## NEBRASKA CAPITOL ENVIRONS COMMISSION

## **Item 2: Residential street rehab project near McPhee School**

CITY OF LINCOLN, NE (2020)  
 PAVING REHABILITATION OF THE  
 McPHEE SCHOOL NEIGHBORHOOD  
 PAVING C.I.P. #705270

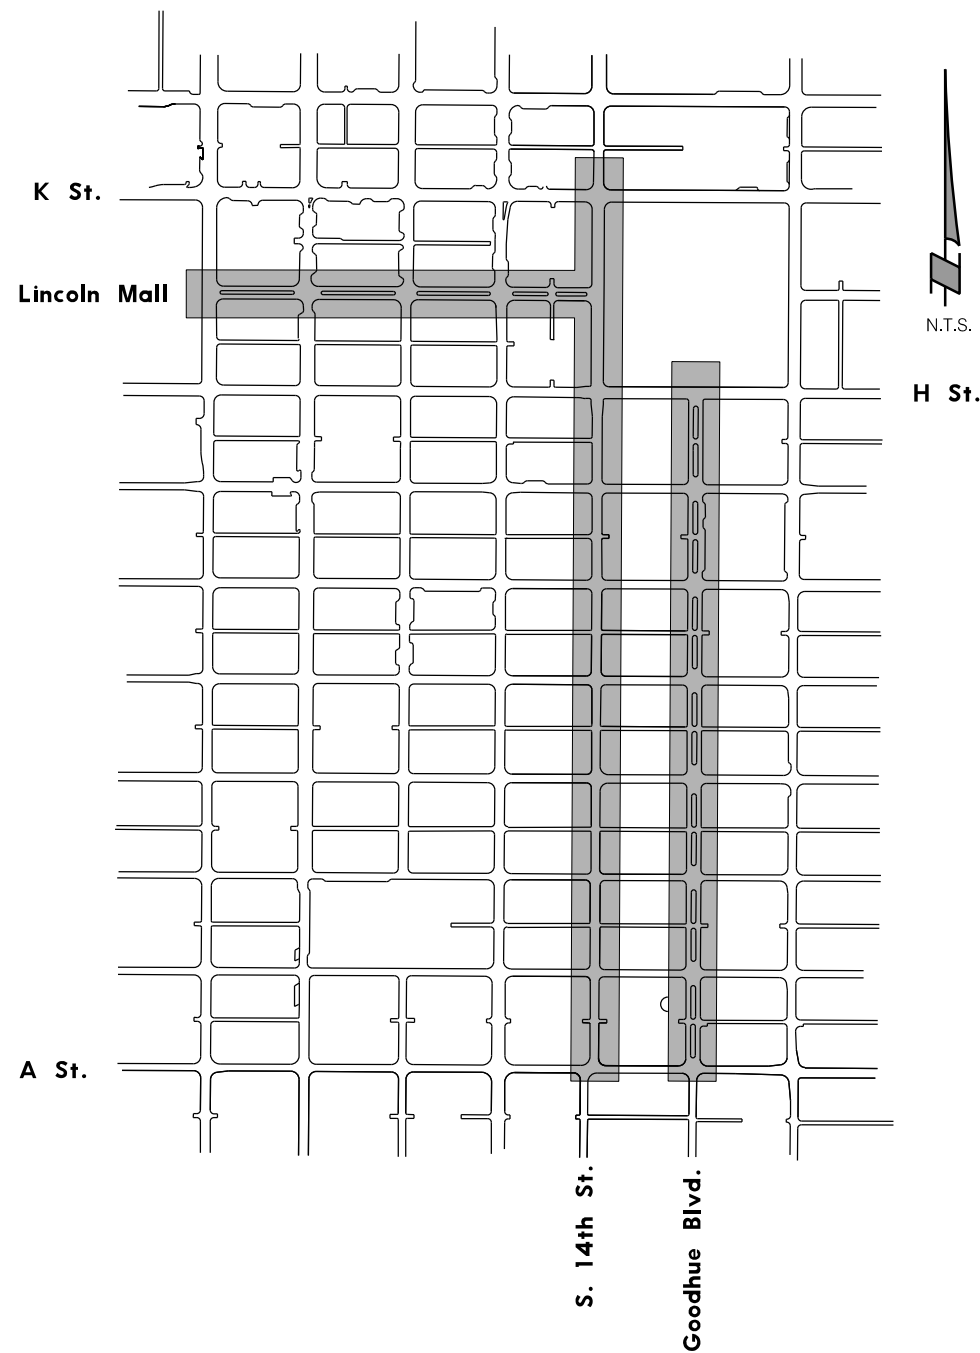
These improvements are intended to enhance the condition and usability of the affected streets and sidewalks. For the most part, they should have little to no impact on the visual quality or character of the Capitol Environs District. One possible exception to this would be the curb ramp improvements along Lincoln Mall. Most of the existing curb ramps on Lincoln Mall were constructed with a colored concrete that differentiates itself from the sidewalk. These same ramps are also surrounded by decorative paver fields that serve as a visual and textural landing zone for pedestrians entering or exiting an intersection. LTU, based on long-term maintenance and liability concerns, is proposing to replace the colored concrete and brick pavers with standard grey concrete in scenarios where curb ramps and sidewalks are being replaced or realigned. Using Lincoln Mall and S 12<sup>th</sup> Street as an example, the two southern corners of this intersection (as shown below) include ADA ramps that will need to be replaced and connecting sidewalks that will need to be realigned to make them fully compliant. As part of this work, it is being proposed that the paver fields be removed and replaced with concrete.

*The photographs above show the southwest and southeast corners of Lincoln Mall and S 12<sup>th</sup> St. As part of the effort to make the curbs ramps ADA compliant, the paver fields at these corners are proposed to be replaced with grey concrete.*

The existing decorative pavement treatments at the corners of the Lincoln Mall intersections play a role in the establishment of the rhythm and organization that Design Standard 18 references. Ideally, improvements at these nodes should not disrupt that rhythm and organization. While the preferred course of action would be to preserve and/or restore the existing paver fields as much as possible, LTU's concerns about their ability to maintain these enhancements long-term are valid. Still, their approach will result in an inconsistent visual aesthetic at the corners of Lincoln Mall's intersections that does not fully align with the expectations of the design standards.

*Recommended Finding: The proposed residential rehab project generally conforms with the Capitol Environs Design Standards, except that the proposed ADA compliance work at the corners of Lincoln's Mall's intersections deviates from the intent of Design Standard 18.*

*Recommended Action: Approval of a Certificate of Appropriateness for the residential rehab project, under the condition that the applicant revise the design to establish a consistent approach to the pavement treatments at the corners of Lincoln Mall's intersections.*
